Economic Commission for Europe**Inland Transport Committee****World Forum for Harmonization of Vehicle Regulations****Working Party on General Safety Provisions****129th session**

Awareness of the Proximity of Vulnerable Road Users:**UN Regulation No. 46 (Devices for Indirect Vision)****Proposal for the 07 Series of Amendments to Regulation
No. 46 (Devices for Indirect Vision)****Submitted by the expert from Germany on behalf of the Task Force on
UN Regulation No. 46***

I. Proposal

Figure 1a

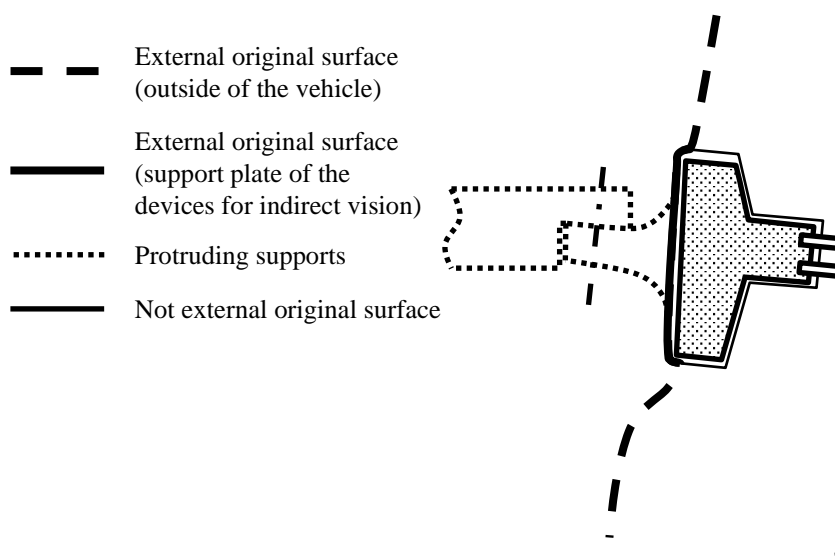
- "2.7. "External original surface" means the outside of the vehicle including the bonnet, the lid of the luggage compartment, the doors, the wings (**fender**), the roof, the lighting and light-signalling devices, the visible strengthening

components, **the support plate of devices for indirect vision** and additional external original design surfaces defined by the manufacturer excluding protruding supports for devices of indirect vision.

7. Clarification on external original surface: A drawing shall be added to further explain the idea of "external original surface". Additionally, the wording in paragraph 6.1.1.6. shall be amended for clarity.

Figure 1c

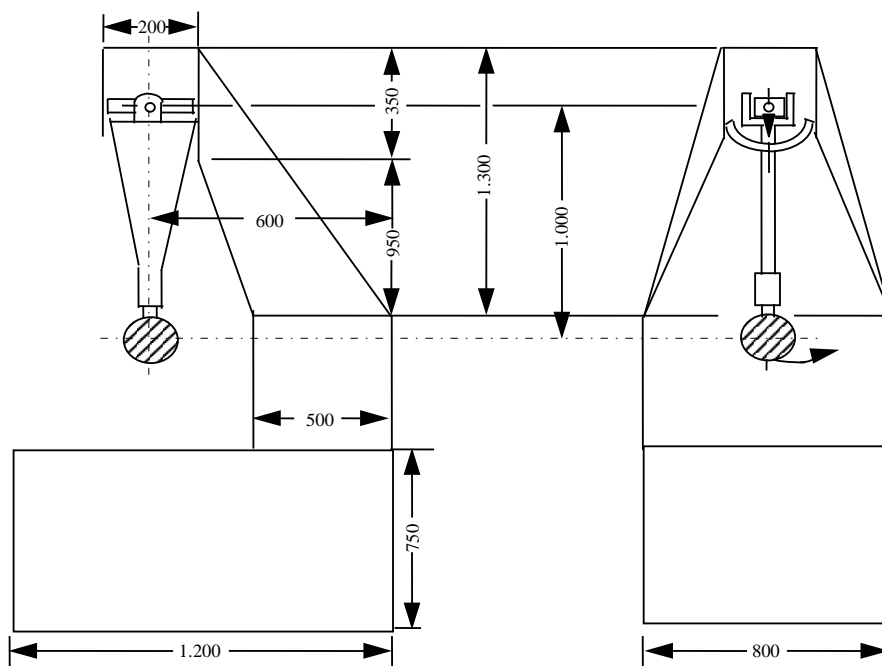
The end of the pendulum comprises a hammer formed by a rigid sphere with a diameter of 165 ± 1 mm, and **at least on the impact side** a 5 ± 1 mm thick rubber covering of Shore A hardness 50.

The end of the hammer may be formed by any other rigid shape having at least on the impact side a spherical shape and a 5 ± 1 mm thick rubber covering of Shore A hardness 50, if the equivalence of this shape is demonstrated through a mathematical model, to the satisfaction of the Type Approval Authority.

9. Pendulum Test: This proposal adds more flexibility in the shape of the hammer. Alternatives to the sphere shall be accepted, if at least on the impact side is a spherical shape. In addition, it shall be sufficient to have a rubber cover at the impact side. All requirements per paragraph 6.3.2.1.2. still need to be fulfilled.

Example 1

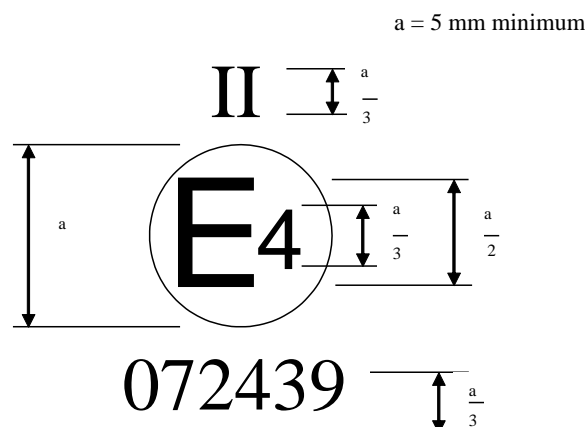
The above approval mark affixed to a device for indirect vision indicates that the device is a main rear-view device, of Class II, which has been approved in the Netherlands (E 4) pursuant to Regulation No. 46 and under approval number ~~052439~~ **072439**. The first two digits of the approval number indicate that Regulation No. 46 already included the ~~05~~ **07** series of amendments when the approval was granted.

One Approval Number for Two Classes

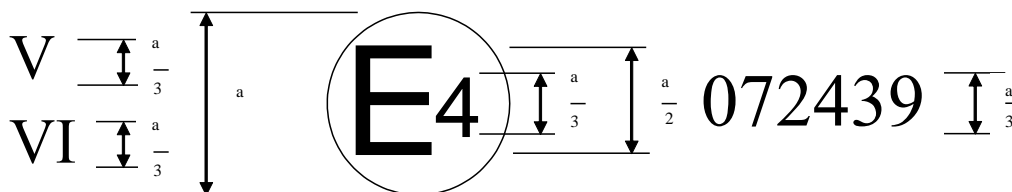
The above approval mark affixed to a device for indirect vision indicates that the device is a close-proximity view device, of Class V, and a front-view device, of Class VI, which has been approved in the Kingdom of the Netherlands (E 4) pursuant to Regulation No. 46 and under approval number 072439. The first two digits of the approval number indicate that Regulation No. 46 already included the 07 series of amendments when the approval was granted.

3. Type-marking: TF decided to introduce the possibility of type-approving devices for more than one “field of view” under one approval number. In addition, it shall be possible to combine the marking of devices for indirect view with the marking of other UN Regulations, e.g. UN Regulation No. 10 on electromagnetic compatibility, if applicable.

Combined Approval Mark for UN Regulation No. 46 and UN Regulation No. 10

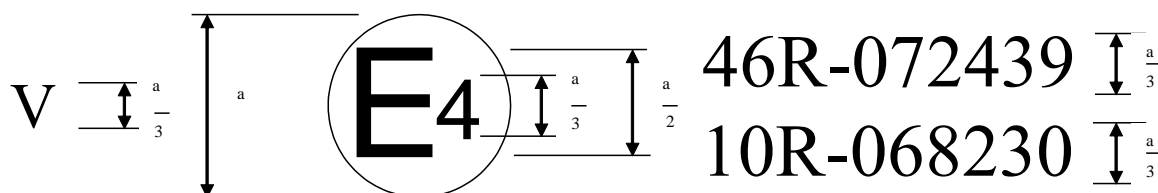
The above approval mark affixed to a device for indirect vision indicates that the device is a close-proximity view device, of Class V, which has been approved in the Kingdom of the Netherlands (E 4) pursuant to Regulation No. 46 and under approval number 072439 and pursuant to Regulation No. 10 and under approval number 068230. The first two digits of the approval number indicate that Regulation No. 46 already included the 07 series of amendments and Regulation No. 10 already included the 06 series of amendments when the approval was granted.

Example 4**Combined Approval Mark for UN Regulation No. 46 (One Number for Two Classes) and UN Regulation No. 10**

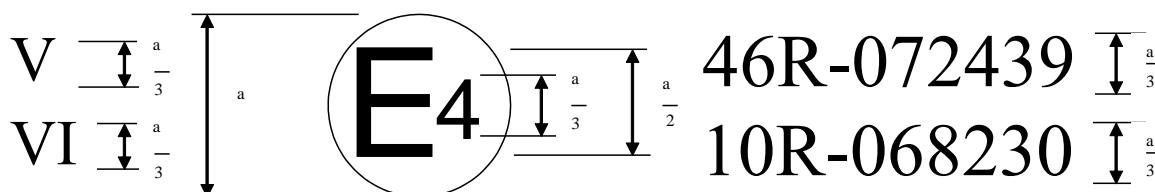
The above approval mark affixed to a device for indirect vision indicates that the device is a close-proximity view device of Class V, and a front-view device of Class VI, which has been approved in the Kingdom of the Netherlands (E 4) pursuant to Regulation No. 46 and under approval number 07243946 and pursuant to Regulation No. 10 and under approval number 068230. The first two digits of the approval number indicate that Regulation No. 46 already included the 07 series of amendments and Regulation No. 10 already included the 06 series of amendments when the approval was granted.
